CITY OF KELOWNA

MEMORANDUM

Date: February 2, 2005
File No.: (3060-20) **DP05-0009**

PURPOSE: TO SEEK APPROVAL OF AMENDMENTS TO THE FORM AND
CHARACTER OF A PREVIOUSLY AUTHORIZED
DEVELOPMENT PERMIT DP02-0117

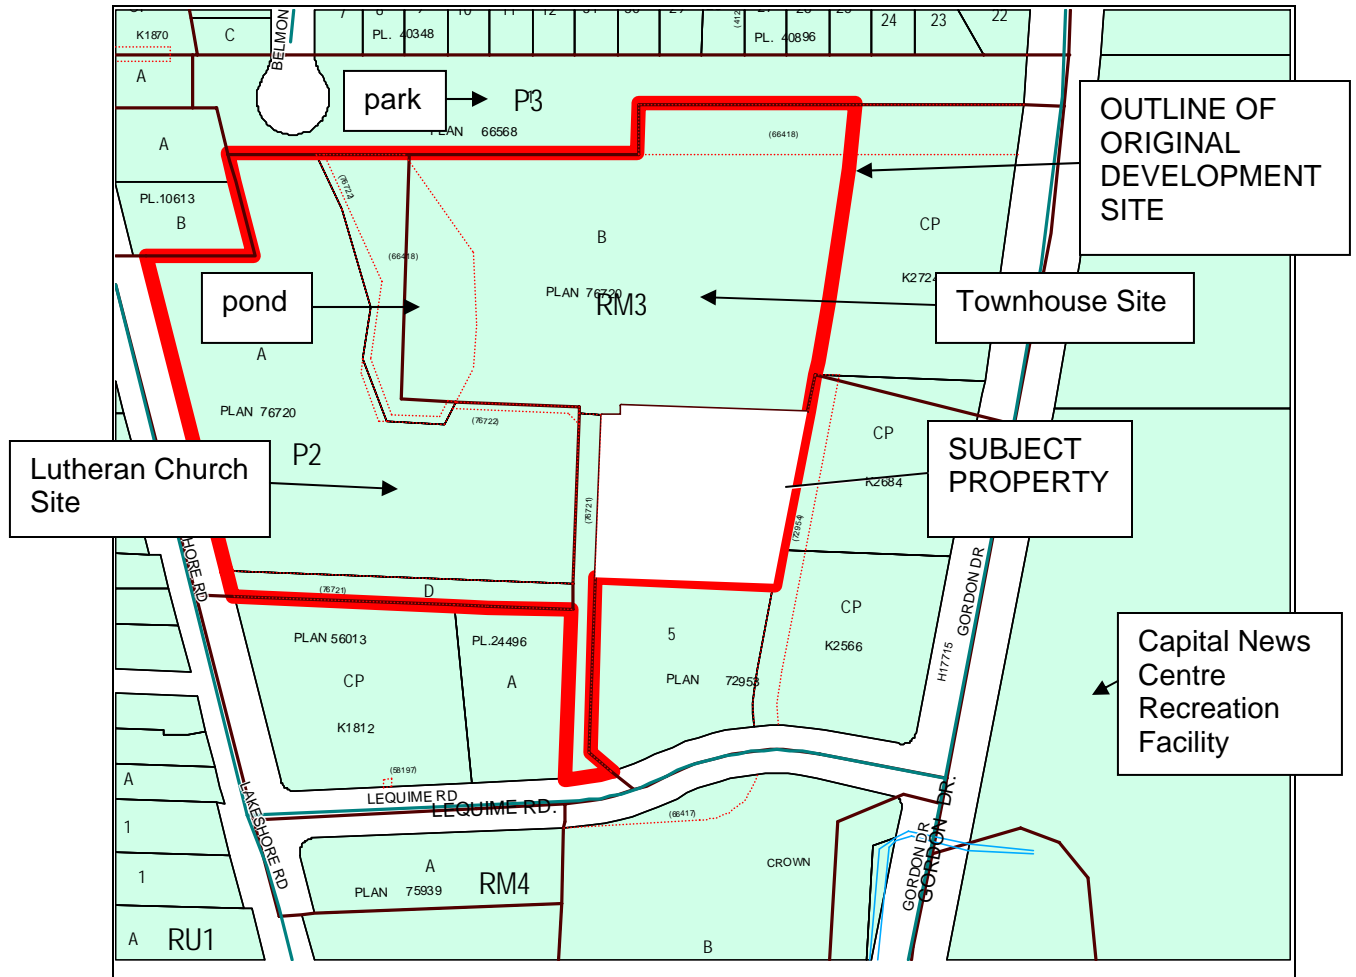
The proposed building is very similar to the building approved by DP02-0117, except for the ends of the building. The building approved by DP02-0117 did not have upper floor units at the ends, in order that there was an element of stepping down of the building mass on the upper floors at the end of the building to minimize impact on adjacent properties.

This revised proposal includes full residential units on the upper floor to both ends. The building designer has stepped up the adjacent gable roof end elements to impart the visual impression that there is a minimal stepping down of the roof line at the corner units. However, there are still residential units proposed to be constructed to the upper floor areas of the building ends.

The changes that will be visible relate to the stepping down of the corners of the building ends, a design element that was recommended by the Advisory Planning Commission. It is this change to the building that causes the Planning and Corporate Services Department concern, as this element was the result of recommendations of the Advisory Planning Commission.
